**BOARD OF ZONING ADJUSTMENT
STAFF REPORT****Date: May 1, 2017****CASE NUMBER**

6104

PARKING SURFACE: Variance to allow aggregate surfacing for a parking area in a B-3, Community Business District.

SITE PLAN

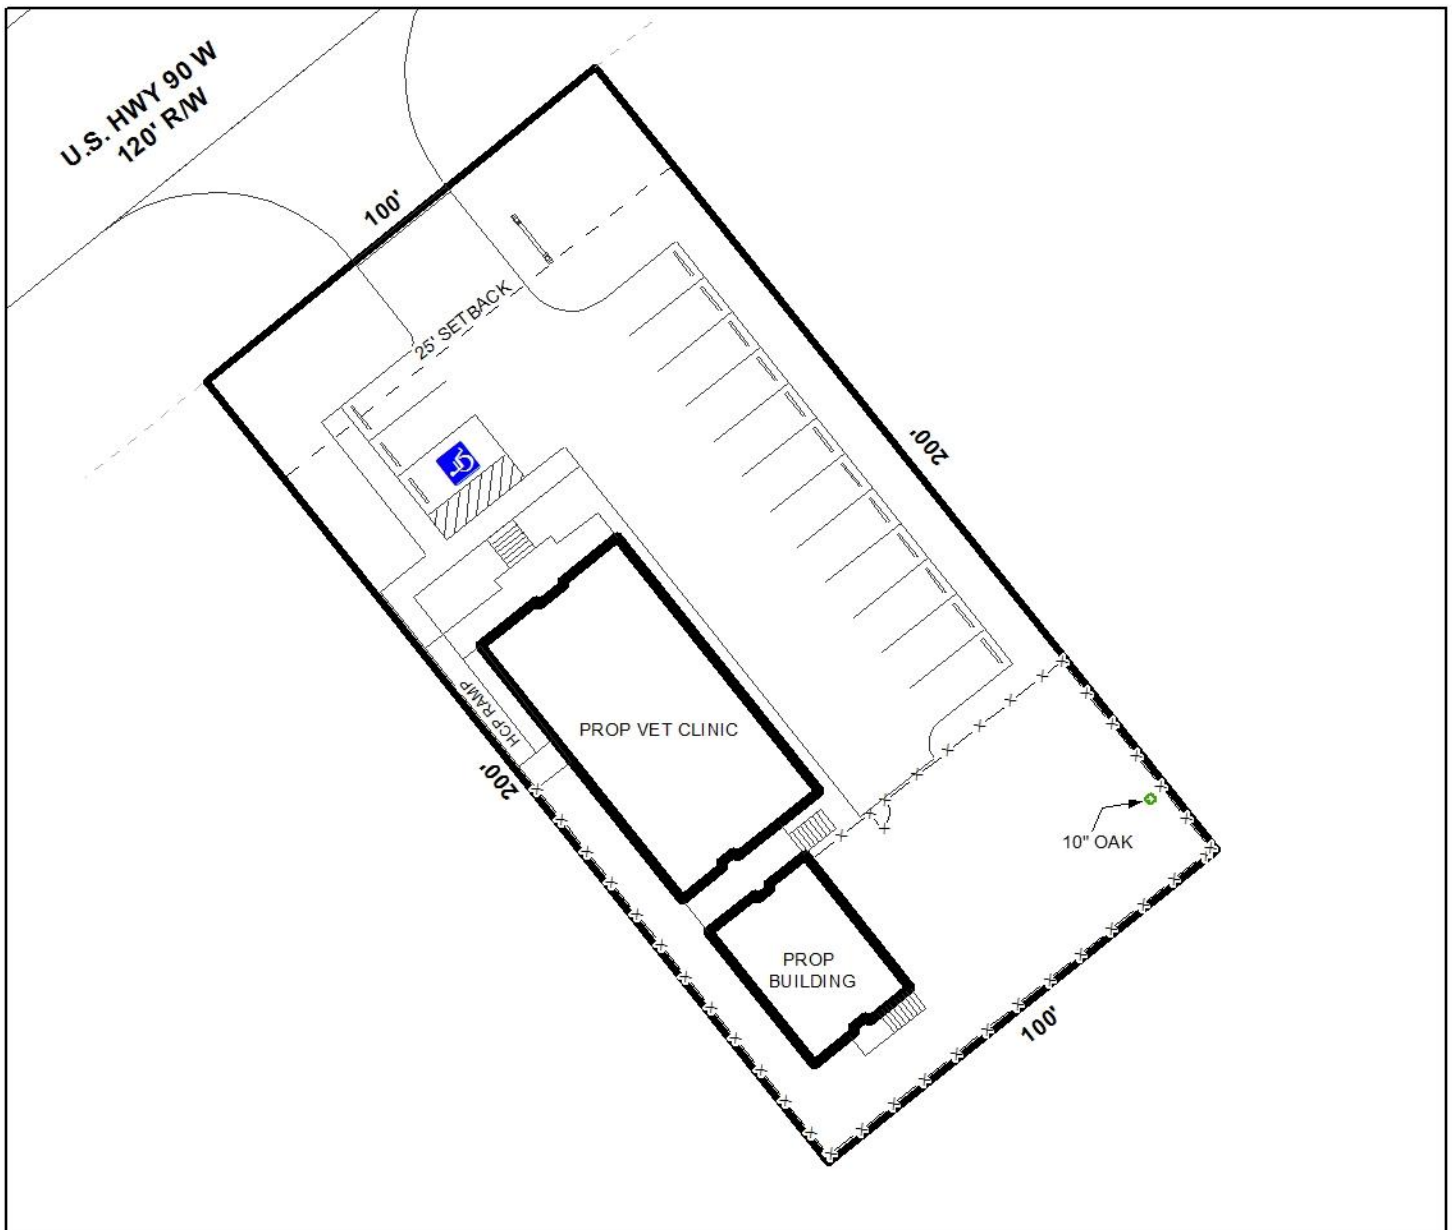
SURFACING VARIANCE: If the aggregate surfacing is approved for use the applicant will need to have the following conditions met:

- a. The handicapped parking spaces and the vehicular access to and from them must be paved (asphalt or concrete).
- b. Submit and receive a Land Disturbance Permit for the proposed site development through Central Permitting.
- c. Submit a ROW Permit (ALDOT and City of Mobile) for any proposed work within the Public ROW. Aggregate surfacing will NOT be allowed within the public ROW.

If the surface variance is approved, bumper stops should be included on the gravel surface to delineate any required parking spaces. An ALDOT permit is required for any work in the right-of-way. Aggregate cannot extend into the right-of-way and cannot be used in the areas designated as the accessible path from the required handicap space to the building.

As the applicant mentions, the proposed site improvements are for a veterinary clinic. The site plan provided illustrates two buildings connected by what the applicant states is breezeway, as well as a parking lot surfaced with aggregate, with 15 parking spaces; one of which is and van accessible and would be paved with concrete. Parking is delineated by bumper stops (and lines for van accessible parking), and compliance with the standard driveway and parking stall dimensions required by the Zoning Ordinance is illustrated. Also, the combined area of the two proposed buildings is 3,092± square feet, thus requiring 11 parking spaces; therefore, the site would be served by an adequate amount of parking.

Tree and landscaping calculations are provided but, if approved, should be revised to indicate that 60% of required landscaping should be provided between the front property line and the front of the building, not 7.2%. Also, while tree calculations indicate the site would exceed minimum tree planning requirements, no proposed trees are illustrated on the site plan. As such, if approved, revision of the site plan to illustrate full compliance with Tree and Landscape Ordinances would be required.

A dumpster is not depicted on the site plan, therefore any dumpster placed on the property must be in compliance with the current enclosure and sanitary sewer connection requirements of Section 64-4.D.9. of the Zoning Ordinance and must be illustrated on any revised site plan(s); or,

The site fronts U.S. Highway 90 West, a proposed major street with a future right-of-way width of 250'. Any proposed development must comply with future right-of-way requirements, the implication being that the proposed location of the main building will be within the required front setback of U.S. Highway 90 West; and, as such the site plan should be revised to reflect this requirement. However, the change of the building location will necessitate a change to other aspects of the site plan, thereby rendering full review of the request impractical.

With regards to the applicant's request for aggregate surfacing, such material is not approved due to the possibility of aggregate shifting into the right-of-way and onto adjacent properties via tires. In cases where the basis for a Surfacing Variance has been justified, either large construction equipment with off-road capabilities or the storage of heavy equipment on the property was persuasive considering such activity and use of the property could adversely impact more traditional surfacing (e.g. concrete, asphalt, etc.). Neither condition would apply to the subject site.

While aggregate surfacing may benefit the site with respect to drainage in a flood zone, Staff has not been provided with information substantiating that traditional surfacing of a parking lot could not do so, either; or, that traditional surfacing would inhibit or impair drainage. As such, approval of the request may establish a precedent regarding similar development of commercial properties not otherwise intended by the Map for Mobile Comprehensive Plan in a Suburban Corridor.

- 4) The site plan does not reflect the development requirements that apply due to the site abutting a proposed major street within a proposed right-of-way width of 250'.
